LOST CREEK ISR, LLC

**Re: Lost Creek Project Environmental Report; RAI Responses
Docket No. 40-9068
TAC No. LU0142**

Please find behind this cover, in duplicate, Lost Creek ISR, LLC's responses to the RAI issued by NRC on March 16, 2009 with regard to the Environmental Report.

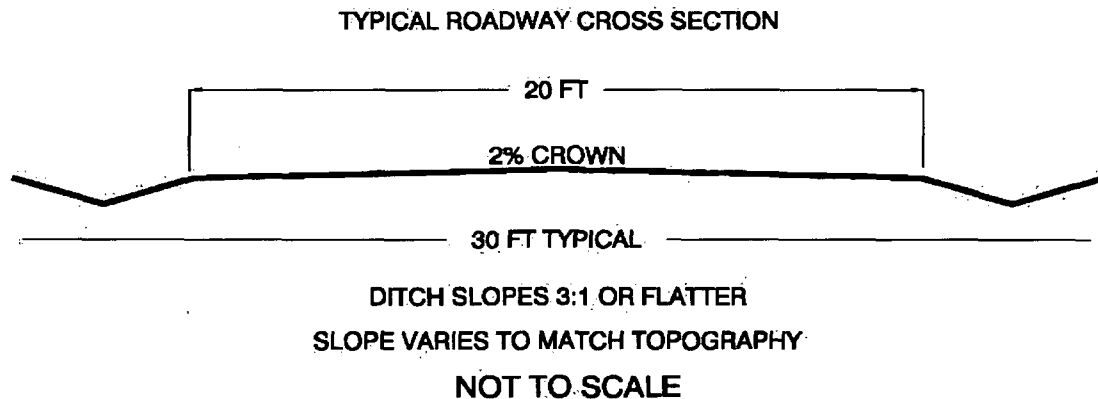
3) *From Sec. 4.3.2 ER identify the roads would be upgraded, and how would they be improved.*

Because the Lost Creek Project and the proposed access routes are on BLM property, they will be upgraded to BLM Road Standards as detailed in the BLM Manual, Section 9113. Particularly, the main east-west access two-track roads will be upgraded to the BLM Functional Classification of "Local" for "Level and Rolling" terrain. This design standard has a minimum travelway width of 20 feet and a maximum grade of 10%. The preferred design speed for this specification is 40 miles per hour (mph). A schematic of this road cross-section is provided below.

Figure 1

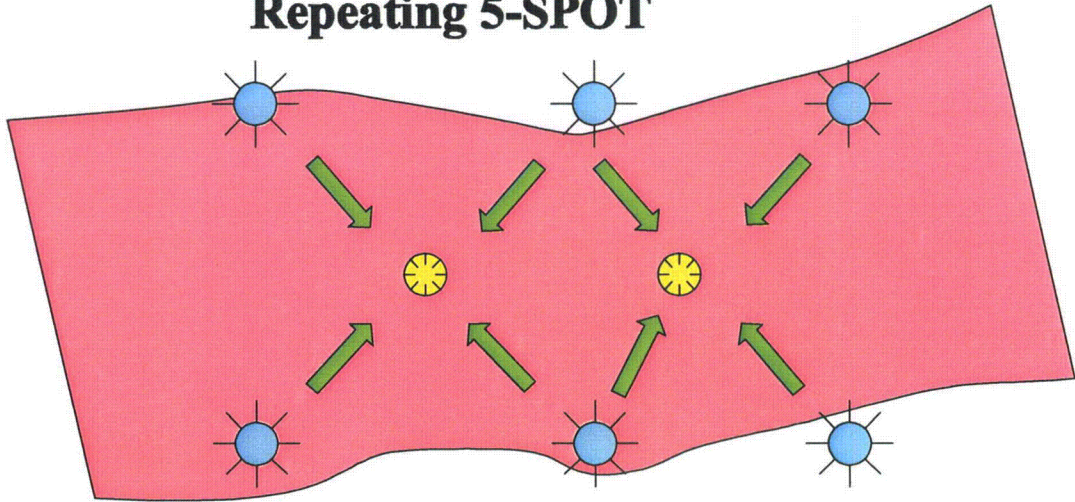
4) From Sec 3.5.5.2 ER provide a more descriptive plan of the proposed operation.

ISR production wells (injection and recovery wells) are laid out over the ore in 'patterns'. Each pattern represents a 'unit cell' consisting of one recovery (production) well and associated injection wells which feed to it. Injection wells are shared by adjacent repeating patterns. There are three basic patterns which may be employed during production at Lost Creek (see attached Figure 2 - Mine Unit Patterns):
